1101 WESTERN AVENUE
Seattle, WA

GGLO
AMLI Residential
Administrative Design Review Response
08.19.2020
SDCI Project #: 3029789-LU

RESPONSE TO ADR

Typ Tower Floor Plan
Design Proposal

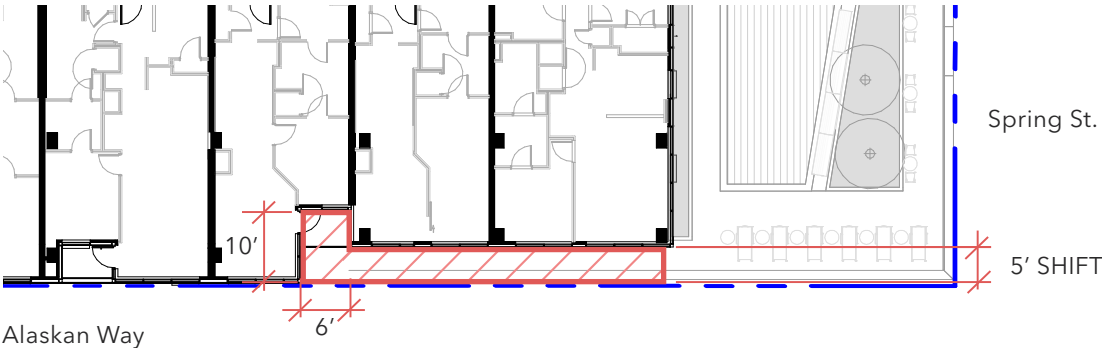
i. Offsetting the faces of the massing elements to create legible modulation;

The modulation has been reconfigured and offsets have also increased at the transition between the North and the South tower. In the revised proposal, the North tower is 5' proud of the south tower. At the transition between the two towers, the balconies recess an additional 5', providing a transition gasket that is 10' from the west face of the North tower.

Perspective of Southwest Entrance parallel to Alaskan Way at sunset - ADR

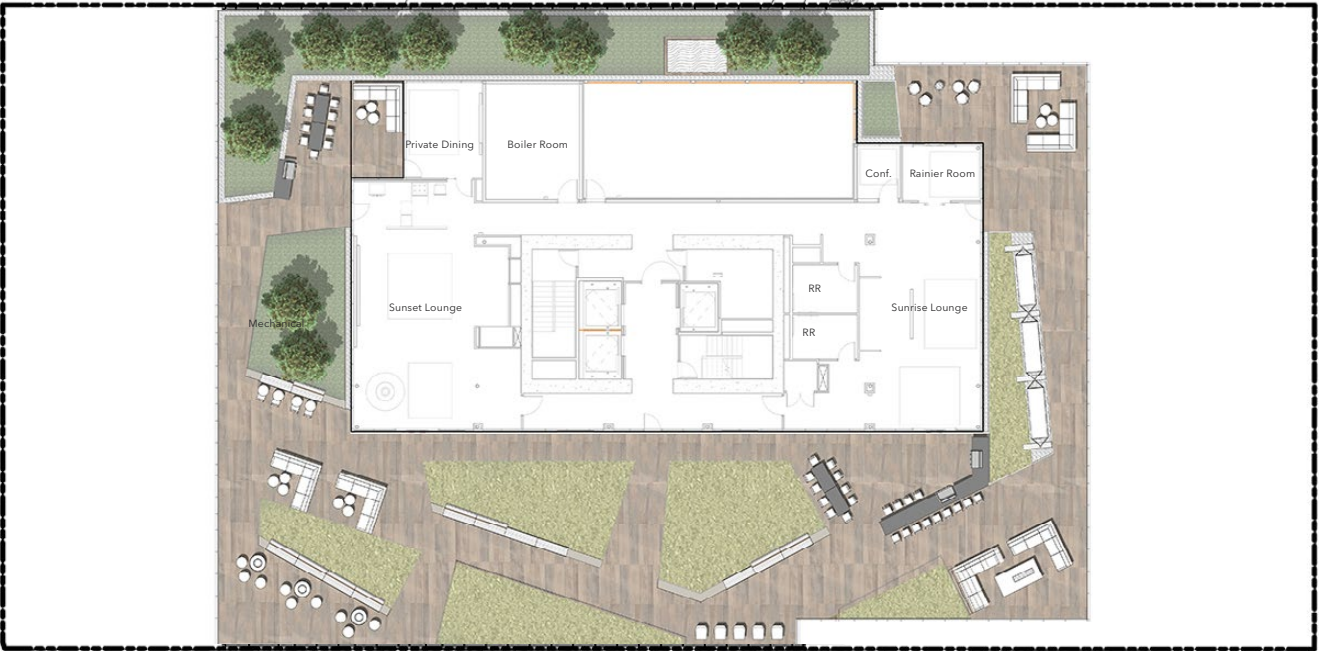
iv. The development of an additional scale element that defines the entry, links the lobby-programmed interior areas behind and knits together the vertical expressions of the tower at the center and the masonry base to the south.

The revised massing prioritizes a scaled element that both defines the entry and links the lobby programmed interior with the vertical expression of the tower. Since the initial Recommendation submittal, the design team has worked to strengthen presence of the entrance in the following ways:

1. **Revision of Overall Massing:** The reorganizing of overall massing, especially at the west façade and primarily at ground level, allows the entrance and related architectural expression to act as its own compositional element. The West entry punctuates the base of the South tower which currently presents at the west façade as the tallest compositional element in the project. Previously, this expression was punched into the brick base. The design team has simplified the architectural language that touches the ground – reducing it down to a brick podium with metal frames and glazing at the retail spaces. This language is accented with a significant entry portal at the residential lobby which helps the building materiality create a programmatic legibility at the ground level.

2. **Updated material expression:** A bronze portal, perforated with a pattern that emphasizes the play of light on water, spans the large void created in the masonry base for the expression of the terminus of the South Tower.

3. **Columns** - Three columns that previously flanked the entrance have been recessed into the building interior to reinforce the independent nature of the entry expression and to allow unobstructed movement from interior to exterior. Most notable is the elimination of a center column resulting in increased expression of levity that reinforces the entrance as an autonomous element.

4. **Deeper overall canopy** - By recessing the building at this location, the design team is able to provide a projecting canopy that is 5’ deep. The canopy is glass to allow for greater visibility of the perforated metal screen expression above.

Level 17 Plan - ADR

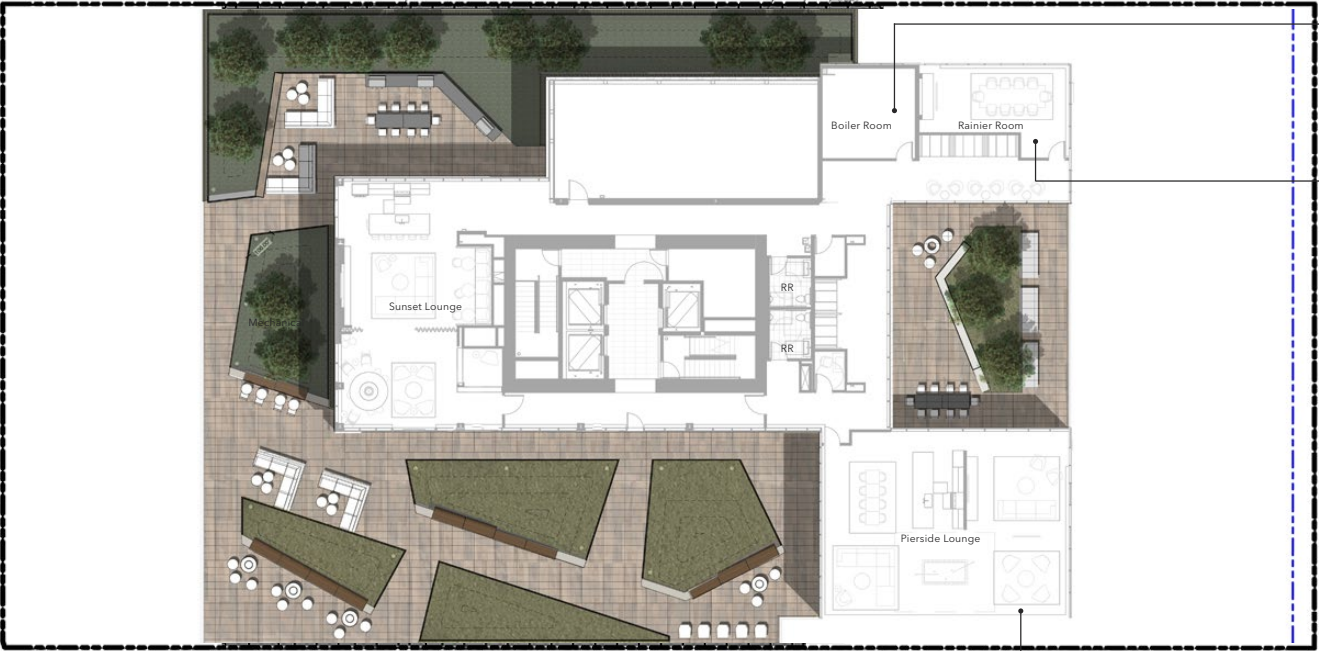
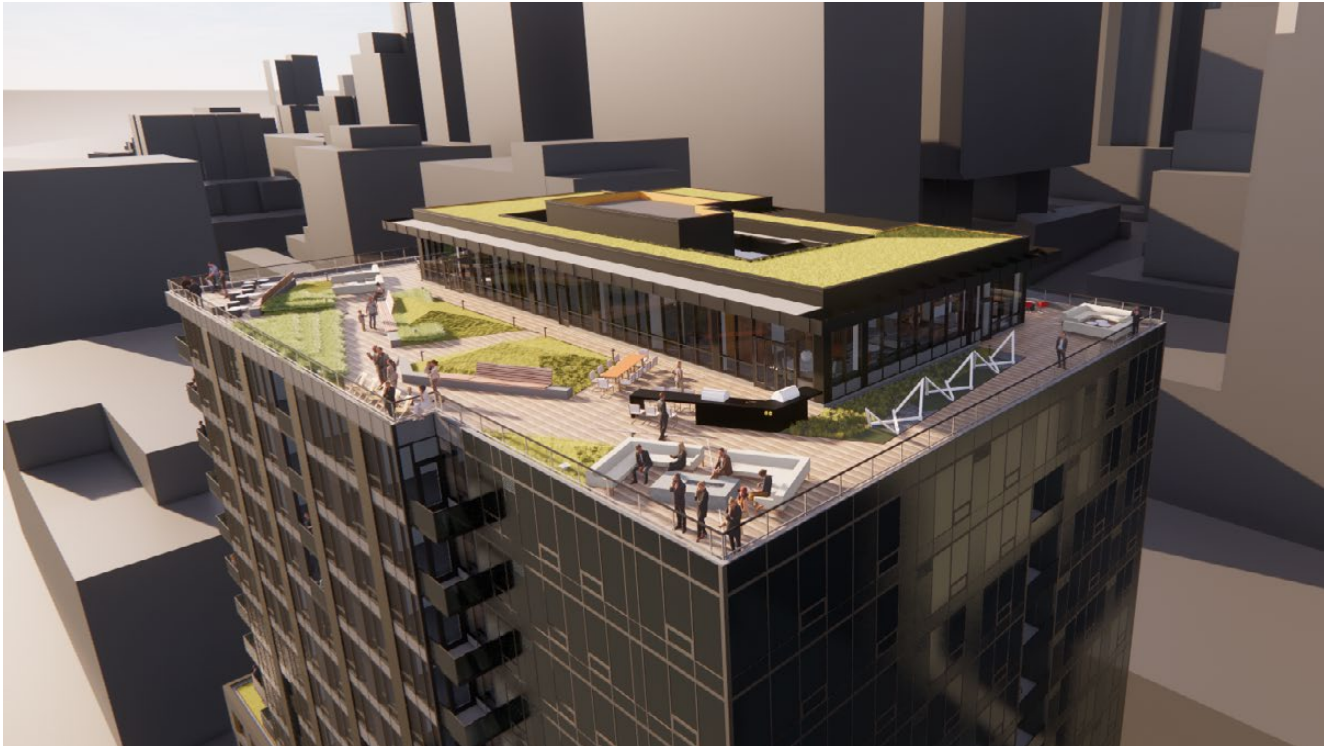
v. Strengthen the expression of the top of the building per the guidance at ADR.

The team reconfigured the top level of the building to better address the goals of this guideline, which are to promote visual interest and variety in the downtown skyline. **Rather than wrapping the core in an even expression, as was done in the previous iteration, the revised rooftop has weighted the majority of the program at the South side of the building, strengthening the expression of the South tower and creating a clear distinction between the two towers.** These revisions significantly strengthen the rooftop expression, resulting in a top floor that provides visual interest and variety and enriches the skyline, while further emphasizing the entrance on Alaskan Way. This holistic expression of the massing reinforces compositional moves. Furthermore, an iconic portal at the south side of the South tower connects a south facing courtyard to the view beyond. Forming a portal around shore pine trees, the building asserts its hybrid status as part landscape and part built form. The project seeks a departure for the additional 6% of square footage required to execute this massing.

Boiler Room moved to minimize impact on north side

Program reallocated to create strong connectivity to tower below.

Aerial View of South Tower - ADR

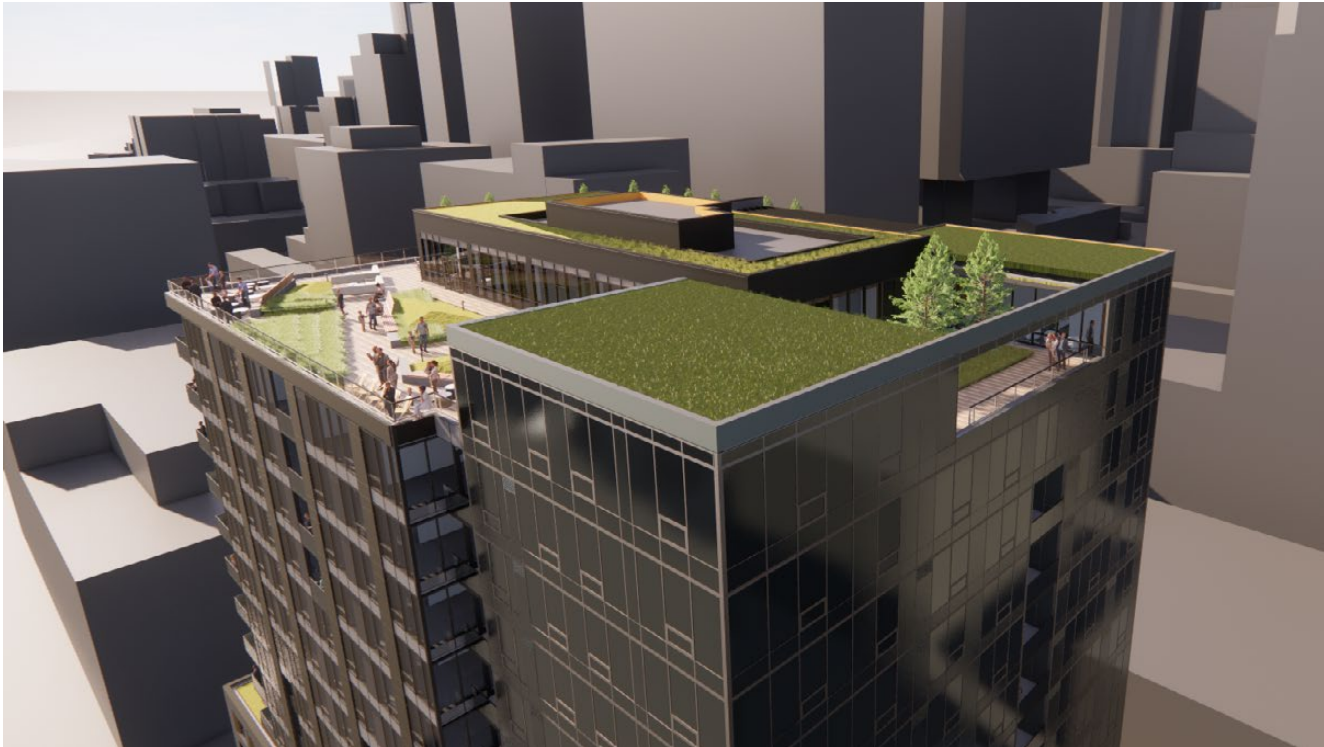
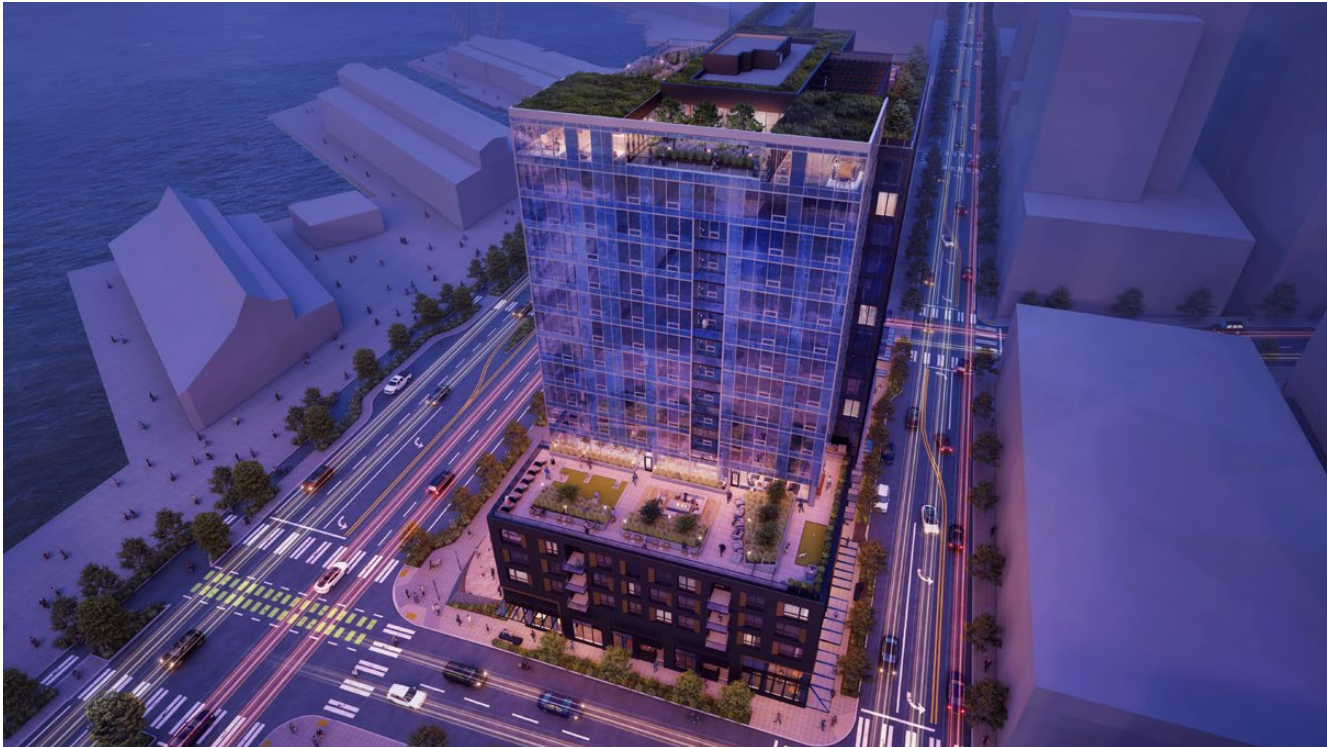
f. Staff recognizes the relocation of the secondary tower element five feet to the east to create a change in plane to strengthen the design concept previously supported by the Board. However, the visual impact of this setback is less strong than anticipated. There are many options to strengthen this, among them Staff suggests increasing the offset distance between the planes, creating a strong distinction at the top between the two tower elements and the elimination of the exterior balconies in this area, which seem to obscure the change in plane. (B-4, A-1, B-3)

The design has been revised considerably since the initial Recommendation submittal. The compositional elements have been revised to further articulate the design as experienced from the ground level as well as from the planned waterfront park. Per staff recommendation, the North tower has been increasingly distinguished from the South tower by pushing the decks at this transition back an additional 5' creating an overall transitional recess that is offset 10' from the west face of the North tower. **Finally, the South tower has been extended to stretch the full height of the building, distinguishing it from the North tower at level 17 where shifted amenity programming provides reoriented vertical height.**

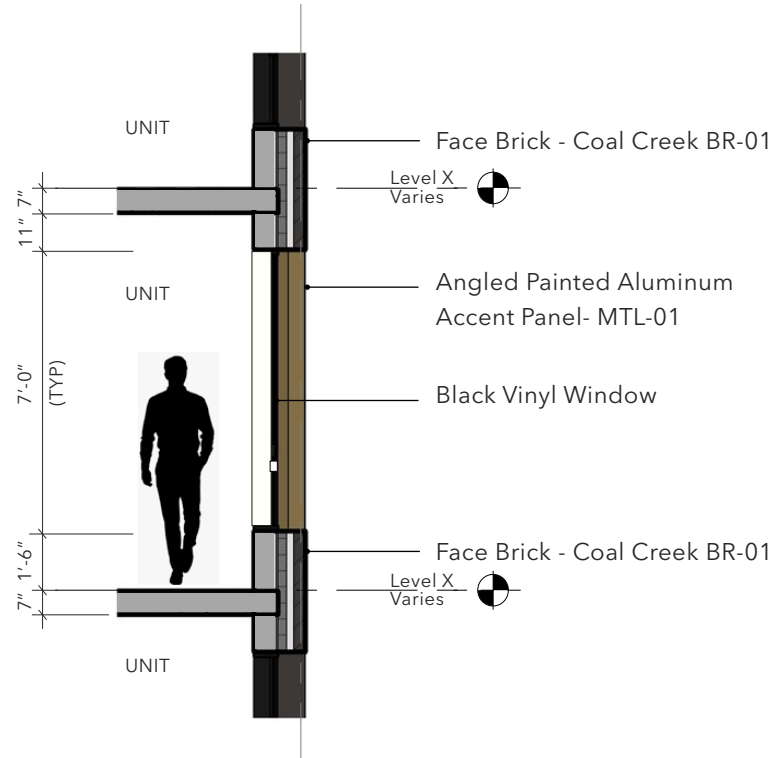
g. The cladding systems for the two tower elements show a high level of contrast in their appearance (p. 5, p. 56, and sim.), including the color, transparency, and reflectivity of the glass. For the recommendation review, provide photographs of the materials board including these and a complete specification for the two glazing types. (B-4)

See below and reference page 68 for full specification and photograph of proposed glass for the North and South towers.

North Tower
Manufacturer: Guardian Glass
System: Window Wall
Glass: SNX 62/27 on Clear (1" double-glazing)
Harmonizing Spandrel Color: Knoxville Gray
Example: Southport Office Complex
Location: Renton, WA

South Tower
Manufacturer: Guardian Glass
System: Window Wall
Glass: SNR 43 on Clear (#2)
Harmonizing Spandrel Color: Subdued Gray (#4)
Example: McKinney and Olive Mixed-Use Facility
Location: Dallas, TX

West Elevation - ADR

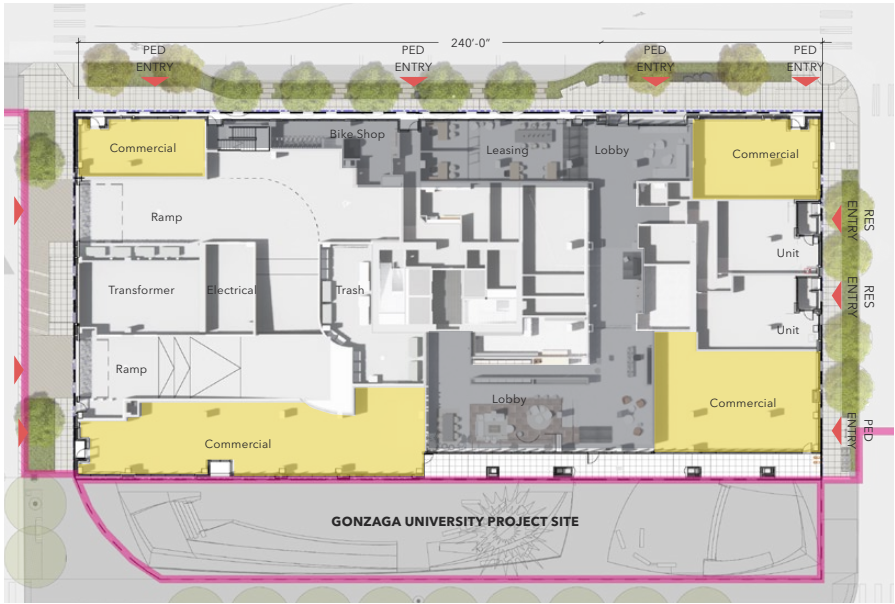
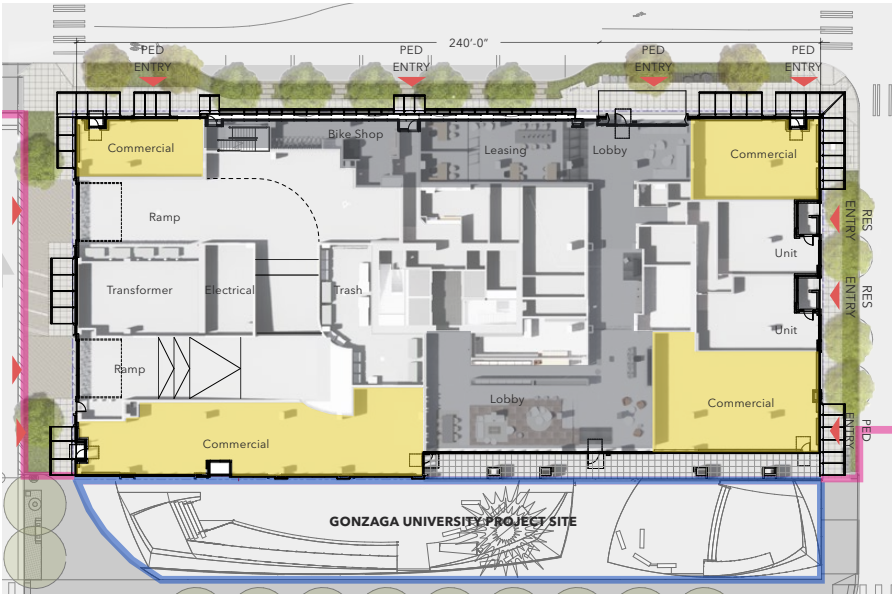
i. Staff notes a disconnection between programming and exterior expression at the west-facing Lobby area and suggests the exploration of a solution to resolve this. (B-4.2)

Increased programmatic legibility was the primary driver for the revision of the brick podium base. The revised diagram creates a consistent expression for retail with metal frames inset in the brick podium, a significant expression for the building entrance and a glazed expression that contains all residential amenity at Western Avenue.

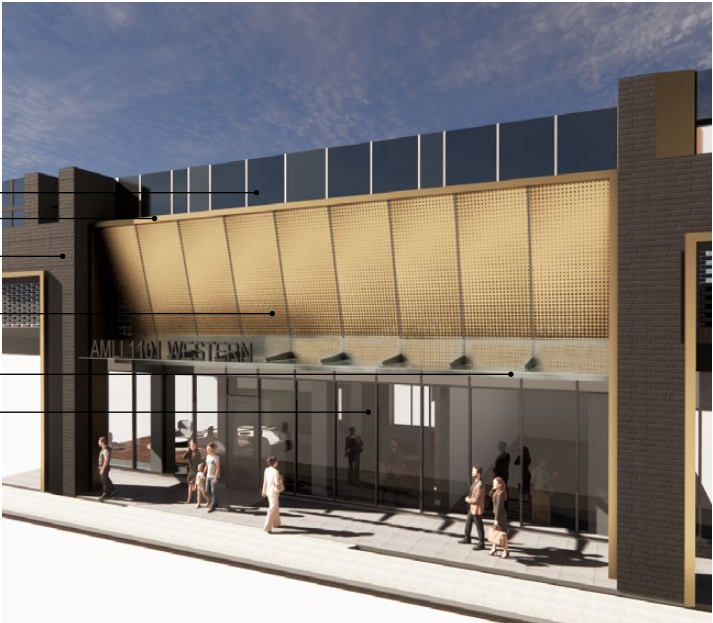
c. Staff appreciates that under certain lighting conditions the golden scrim above these doors may

read as strongly as shown in these renderings, but notes that a three-dimensional architectural solution (rather than simply graphic) will likely be required to create the legibility called for by the Board and in the in the guidelines. Staff recognizes this unique condition and suggests the exploration of multiple approaches to create an entry that is appropriately scaled, clearly identifiable and visible, easily accessible and inviting to pedestrians. (C-4.1, C-4.2)

A number of design solutions were studied before arriving at the preferred expression. For all the reasons previously stated, **the design team believes the current entry expression is appropriately scaled, clearly identifiable and visible, easily accessible and inviting to pedestrians.** The details of this solution include back lit perforated panels in a graphic pattern as described. While changing levels of daylight will have an influence on how this is perceived, the custom perforations and internally illuminated nature of this element will ensure it stands out as unique from the adjacent materials at all times of day and night.
